Interpretation Request

With regards to the application of the Common Interpretation CI-T8, we have an interpretation request as below:

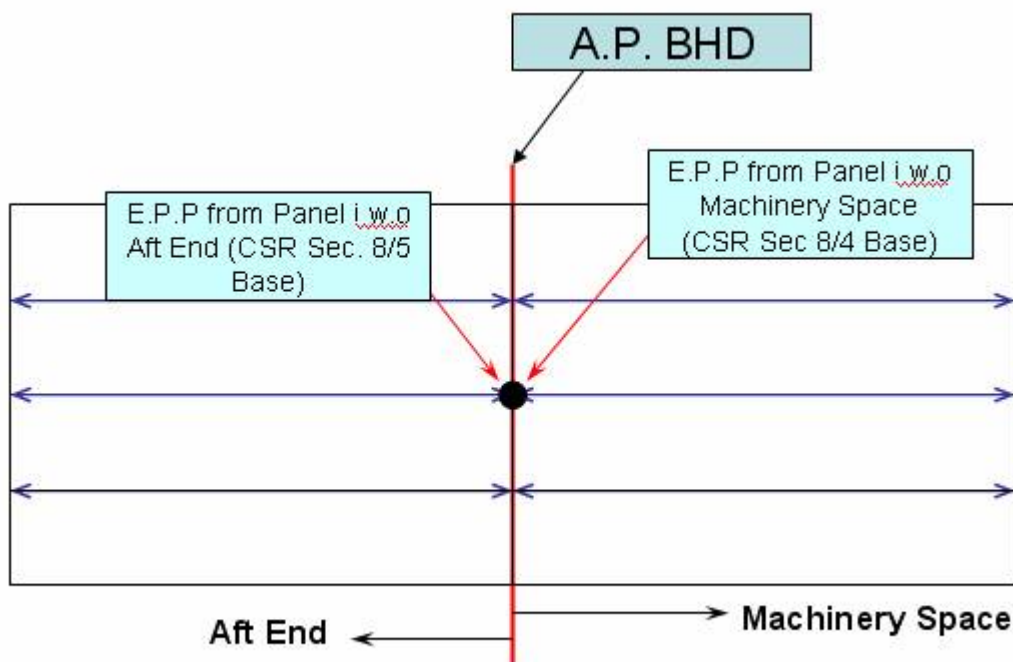
As shown on the above, t_{end} should be used the NET REQUIRED THICKNESS at A.P BHD in the tapering formula.

However, considering the actual structure, a debate are possibly made depending on the considering panels' net required thickness as shown below picture.

1. Regarding to this tapering requirement, should we use the required t_{end} at the E.P.P of the panel i.w.o. Machinery Space (Applicable Rule Sec. 8/4 "MACHINERY SPACE")?
2. or should we use the required t_{end} at the E.P.P of the panel i.w.o. Aft End (Applicable Rule Sec. 8/5 "AFT END")?
